July 25, 2016

## MEMORANDUM

**Re:** Responses to Peer Review of Comprehensive Hydrogeologic Investigation Report for the Paraiso Springs Resort

**Figure 1. Semi-Logarithmic Plot of Drawdown at Well #1**

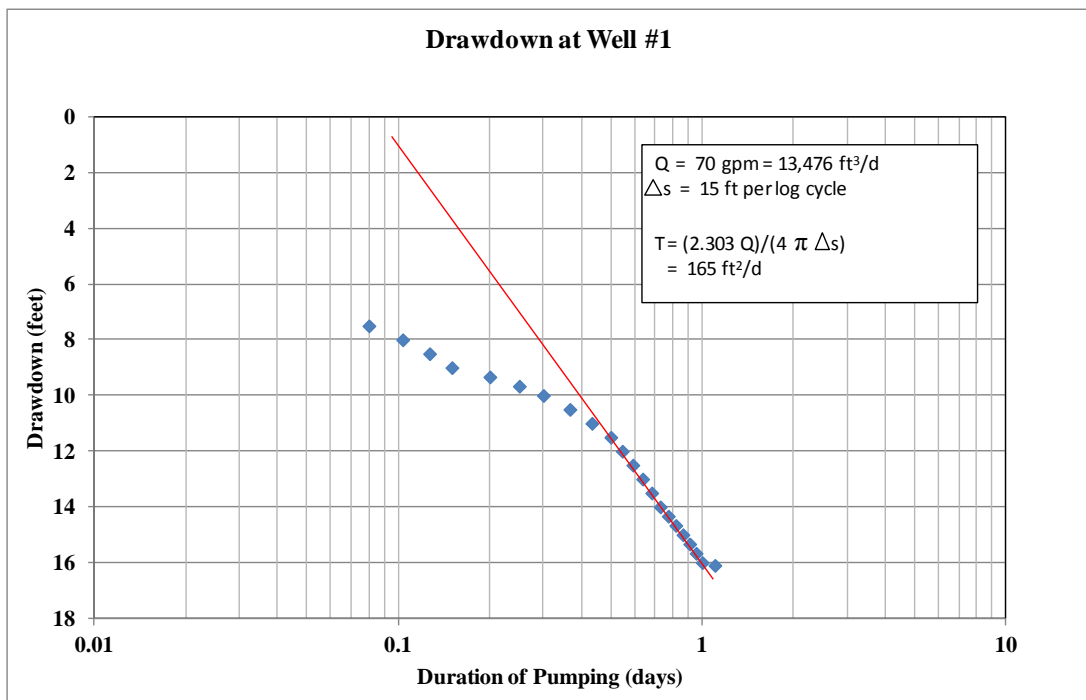
The reviewers commented that the aquifer test of the project's two water supply wells completed by CH2M HILL (2008) deviated from theoretically optimal procedures in some respects. In particular, the reduction in pumping rate at Well #1 from 70 to 58 gallons per minute (gpm) 25 hours after the start of the test complicates the interpretation of subsequent drawdown measurements. While the reviewers considered the results "severely compromised", they noted that "some of the data may be salvageable".

The estimate of groundwater flow through the alluvial aquifer is directly proportional to the estimate of aquifer transmissivity derived from the aquifer test. We re-evaluated the drawdown data for Well #1 to estimate transmissivity based on the first 25 hours of the test, which preceded the decrease in pumping rate and the extension of the discharge hose. Using the Cooper-Jacob straight-line approximation method, a transmissivity of 165 ft<sup>2</sup>/d was calculated, as shown in **Figure 1**. This estimate is almost certainly too low because drawdown at the end of the first 25 hours of pumping had reached approximately 50% of the aquifer saturated thickness. The decrease in saturated thickness increases the drawdown at the well and lowers the resulting estimate of transmissivity.

This alternative estimate of transmissivity is only 18 percent as large as the estimate derived from the specific capacity of Well #1 measured at the end of the 10-day test. Eighteen percent of the original groundwater flow estimate is 129 AFY. Substituting this value into Table 5 of the hydrogeologic report would reduce the sum of total inflows from 797 to 216 AFY, which is still seventeen times greater than the net annual consumptive groundwater demand of the project. Thus, even this unrealistically unfavorable reinterpretation of the Well #1 aquifer test does not alter the conclusion that the project water supply is adequate.

**Figure 2. Semi-Logarithmic Plot of Drawdown at Well #2**

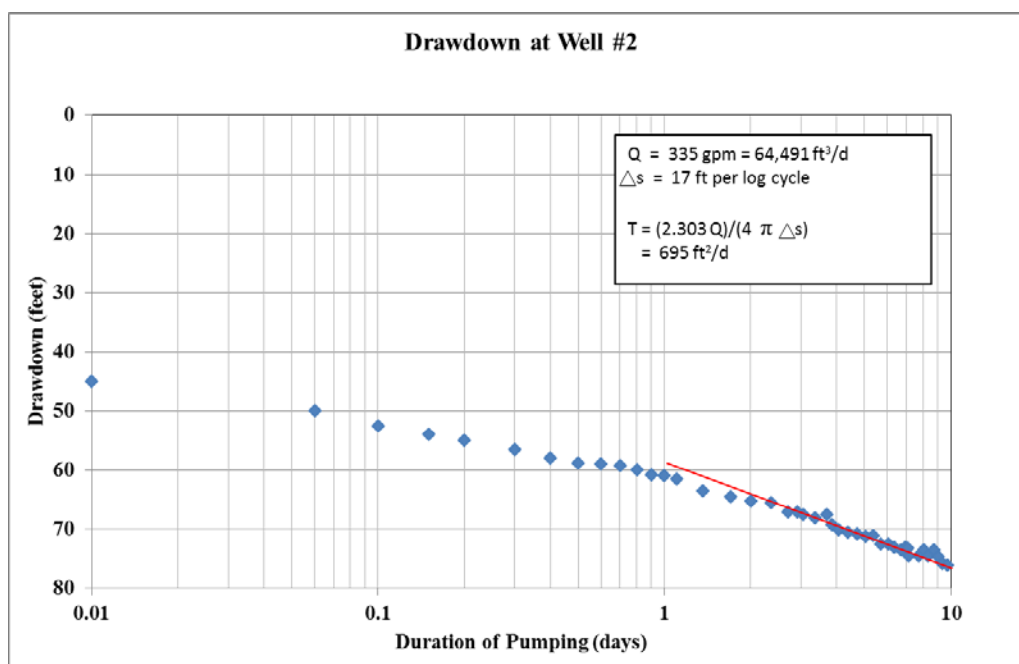
- The reviewers requested a re-evaluation of the Well #2 aquifer test to correct the transmissivity value presented in our report (see response above) and confirm whether recharge or barrier boundaries might have influenced drawdown at the well. We note that the transmissivity value of the Tierra Redonda bedrock formation

tapped by Well #2 is not used in our analysis of well yield or drawdown impacts. We also note that the smooth pattern of the linear-scale drawdown plot for Well #2 presented in the CH2M HILL aquifer test report shows no deviations suggestive of boundary effects. Nevertheless, we manually transcribed the drawdown data from the CH2M HILL report figure and re-plotted them on a semi-log graph, as shown in **Figure 2**. The estimate of transmissivity obtained using the Cooper-Jacob straight-line method is 695 ft<sup>2</sup>/d. As expected, the semi-log plot also shows no deviations indicative of boundary effects.
